SEWAGE DISPOSAL SYSTEM

MARYLAND STATE DEPARTMENT OF HEALTH

ADDRESS 3940 College Avenue, Ellicott City, Maryland PHONE 481-8168

SUBDIVISION Beauport Park near 8311 Clarkson Drive LOT 10-6

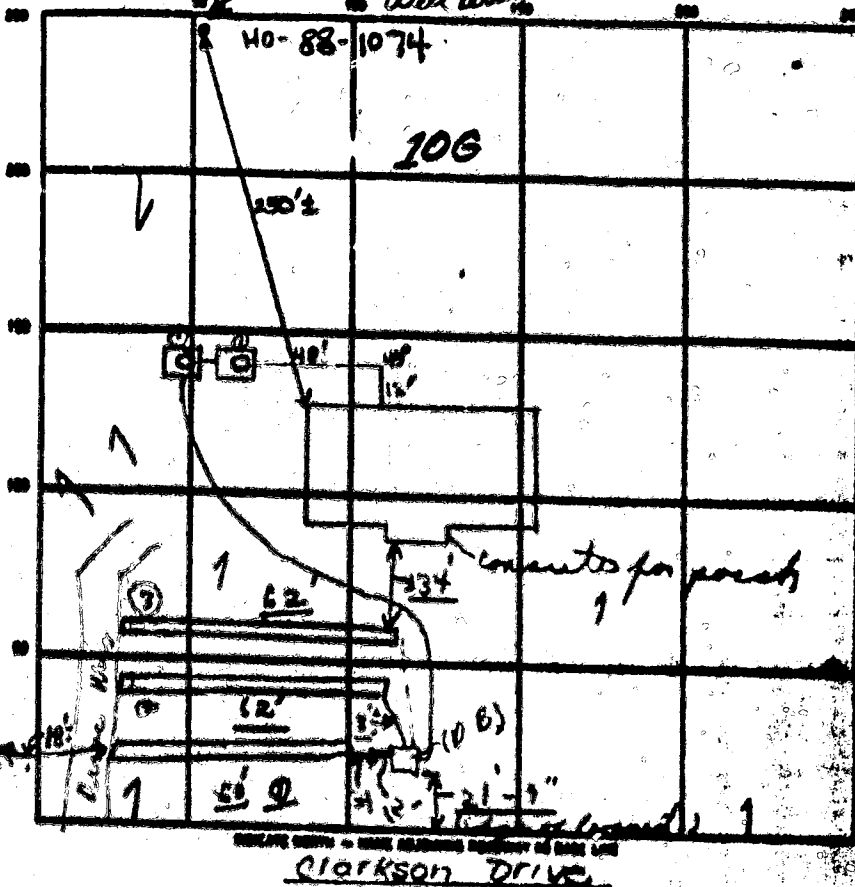
REMARKS 10-14-94 OK to cover from house to ST. drum
11/9/94 met contractor at site @ 11:30. Discussed location of
d.b. and 2 trenches. Trenches to run to left side of lot.
11/10/94 No inspection today. Mal Johnson @ site, who
Note: Pump out - needs to be approved after being
checked. 11/14/94 No electrical put in for stones
in all 3 trenches; need to see ends of well by trench & paper approved to do;

DATE SYSTEM APPROVED 11/30/94 INSPECTOR Charles B. Johnson
11/19 No stones - want for a release 11/30/94 Pump Test with Mr. B. Johnson

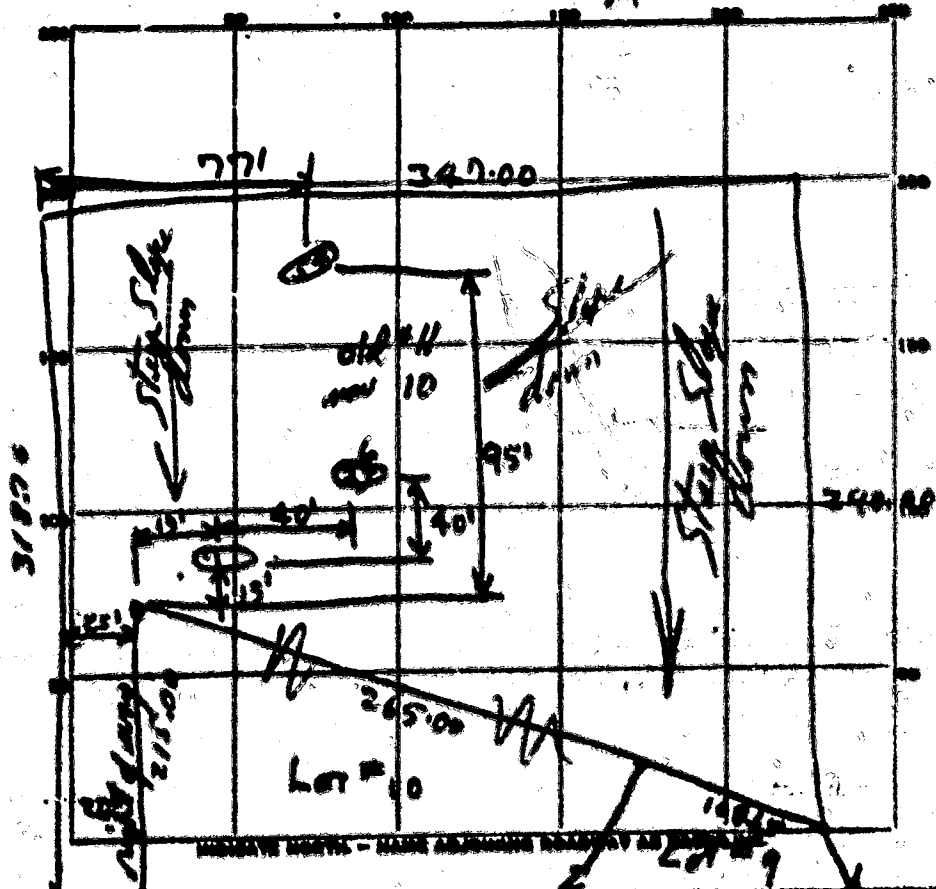
REASONS FOR REJECTION OR WELDING 3-1-89 For perc hole locations and plat approval.
House and well sites are very limited. Front area does not have a well site
and <10,000 sqft of septic area. (DEN)

Lot 10
 Block "G"
 PLAT ONE
 BEAUFORT PARK
 8511 CLARKSON DR.

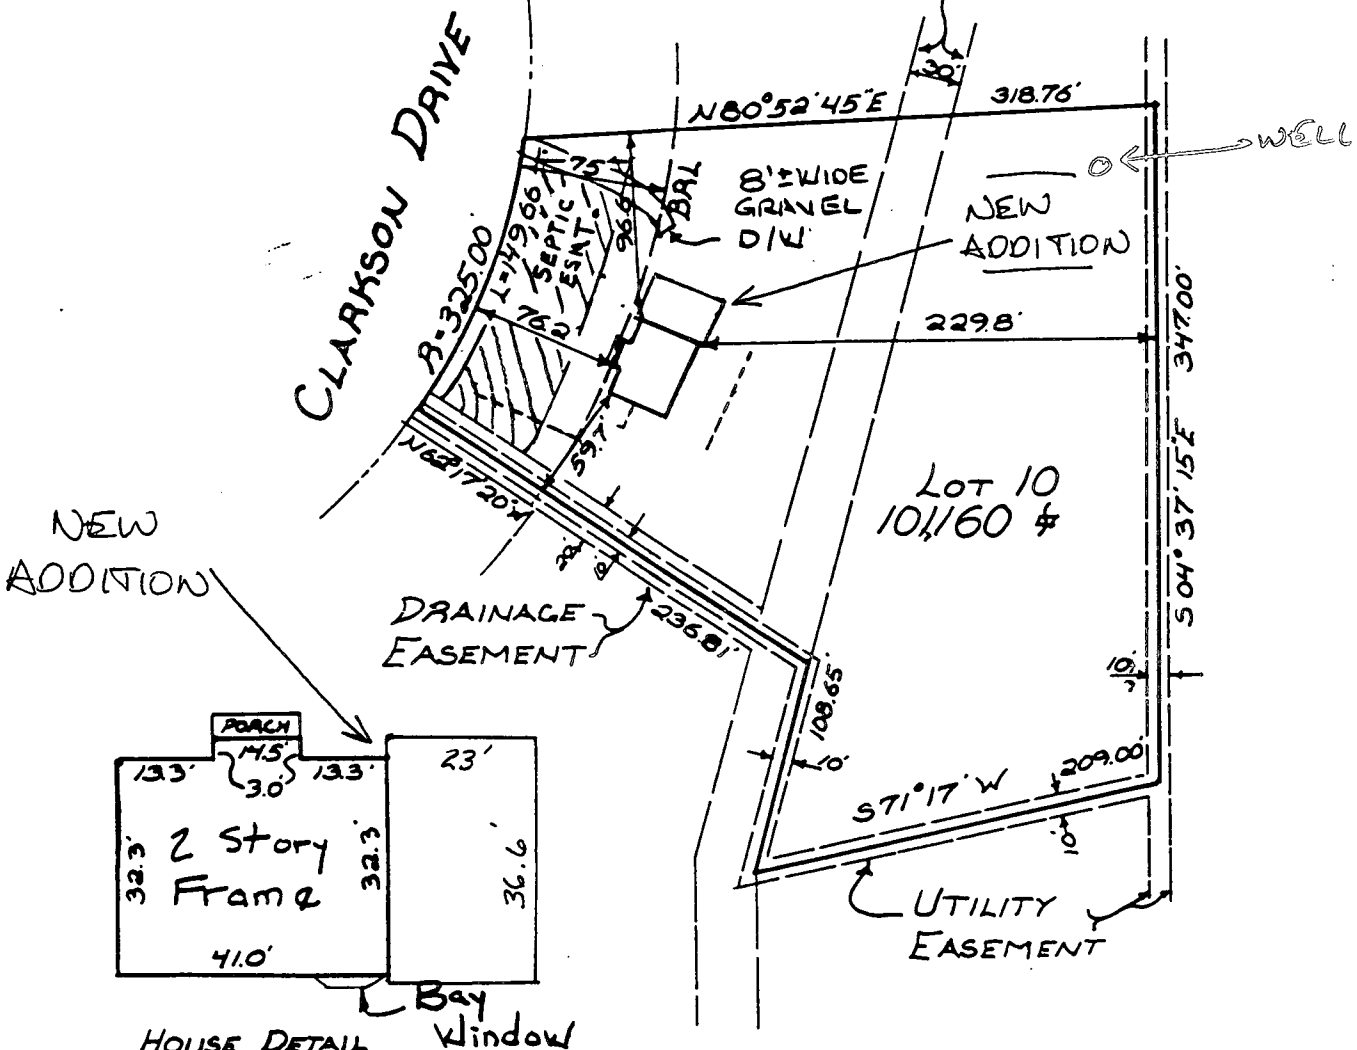
7/25/96 PROPOSED 1350 GALLON ADDITION: EXISTING SEPTIC CAPACITY SUITABLE FOR ADDITION, NO IMPACT TO WELL DISCUSS WITH CW. *Gladys*
DRAINAGE EASEMENT

PERMIT # B00101240

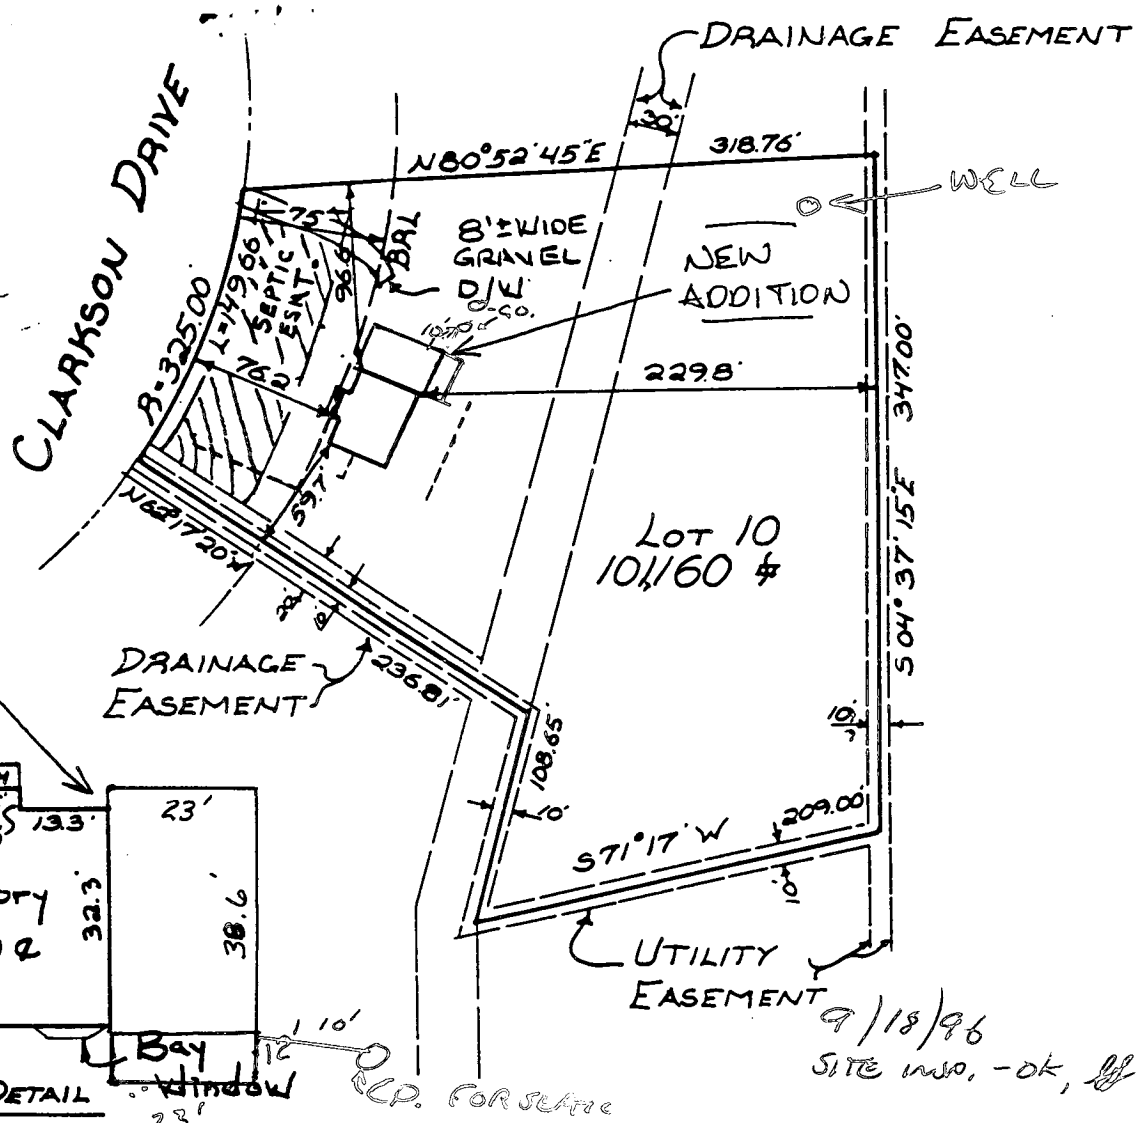
- 1) EXTENDING ROOF 12' TO RR OF HOME (12' x 23') FOR FUTURE PORCH
- 2) REMOVING FRONT GABLE; REPLACING WITH 2 DORMERS JUTTING OUT FROM ROOF
- 3) NO CATHEDRAL CEILING IN FAMILY ROOM
- 4) INSTEAD OF FRAMING; ROOF TRUSSES TO BE USED FOR ROOF STRUCTURE
- 5) NO ~~BE~~ LIVING SPACE ON 2ND FLOOR CHANGED TO STORAGE SPACE TO BE ACCESSED FROM HATCH IN GARAGE

AMENDMENT
APPROVED FOR
WELL AND SEPTIC.
Blomme
SANITARIAN
